**PRODUCT NOTICE****Notice of Potential Product Concern**

Rockwell Automation Library of Process Objects, P_PIDE Version 4.10.02 Critical Anomalies

Reference: 2021-02-001

Date: February 2021

1. Shed Anomaly

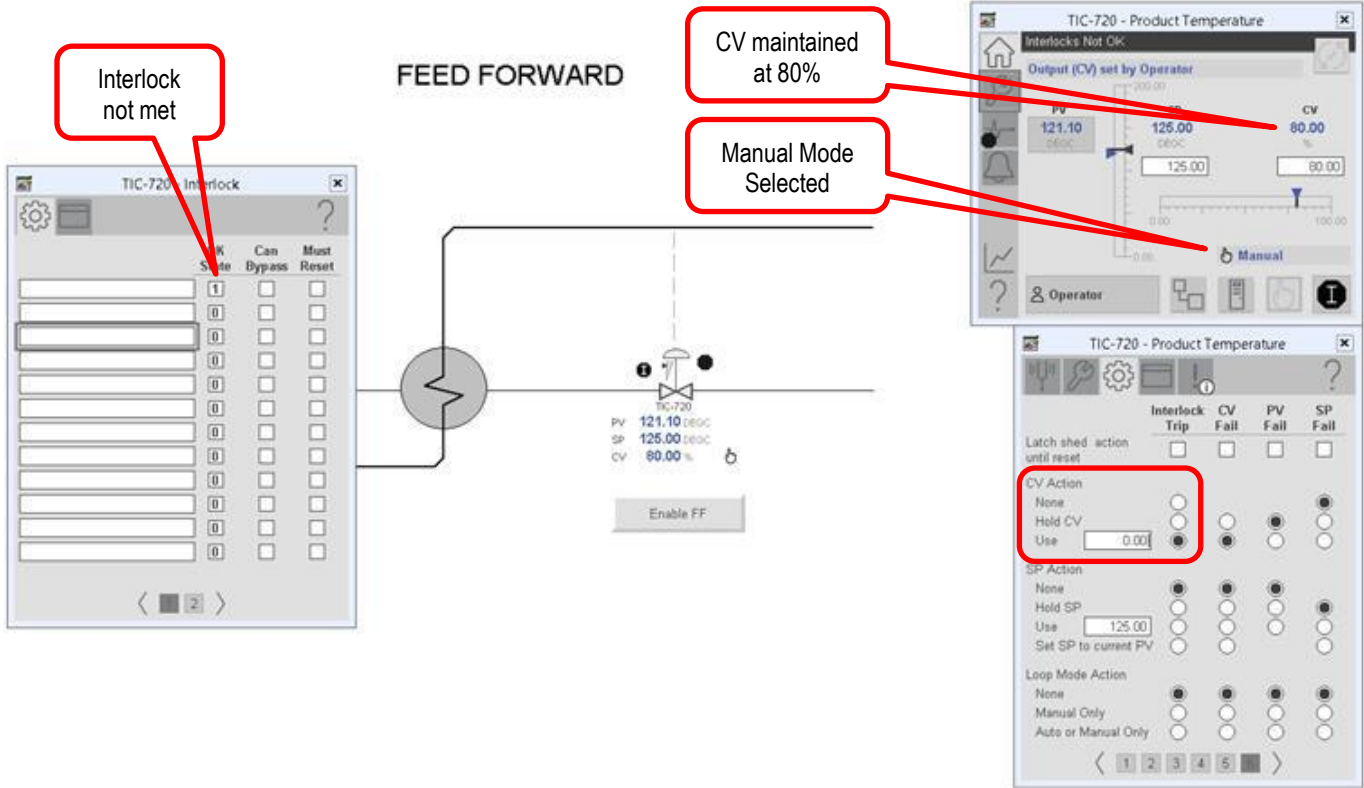
The P_PIDE may not properly default its CV to the configured safe state value if the interlock conditions are not met while in the P_PIDE is in Manual mode.

“Safe state” actions can be configured within the faceplate to be **None** (do nothing), **Hold** (current state at the time of the interlock) or **Use** (a pre-specified value). “Interlocks” can be any number of specified conditions that are required for the P_PIDE to function normally in Auto mode. If the “chain” of interlocks is broken, the P_PIDE is expected to follow the behavior configured for its safe state.

The function works as expected when the P_PIDE is in Auto or Cascade mode but will not when the P_PIDE is in Manual mode, leaving the potential for unexpected machine/equipment behavior.

In addition, the operator can override the “safe state” during an interlock shed condition by simply placing the P_PIDE into manual mode and requesting a specific CV.

Correction required updating to RA Library of Process Objects version 4.10.03 or later. Version 4.10.03 can be obtained from the Rockwell Automation Product Compatibility and Download Center (PCDC) at <https://compatibility.rockwellautomation.com/Pages/MultiProductDownload.aspx?crumb=112>. In the “Search” field enter “Process Library”. Select the “Process Library” result, then the desired version. Follow the instructions to download and install the corrected version 4.10.03 or later.

2. Auto to Manual mode anomaly

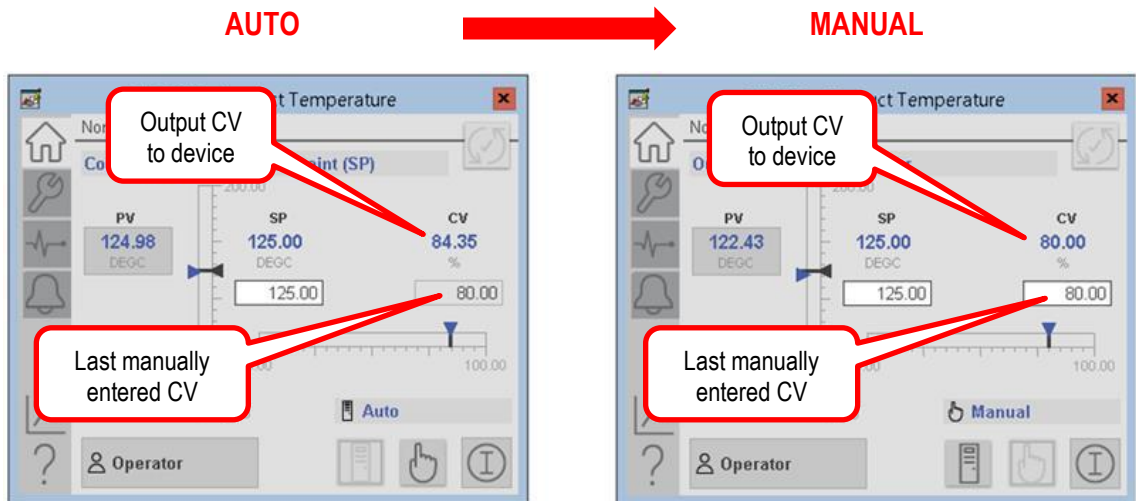
The transition of the P_PIDE from Auto to Manual mode is not bumpless as the CV is incorrectly driven to the last manually entered value instead of starting from the current CV.
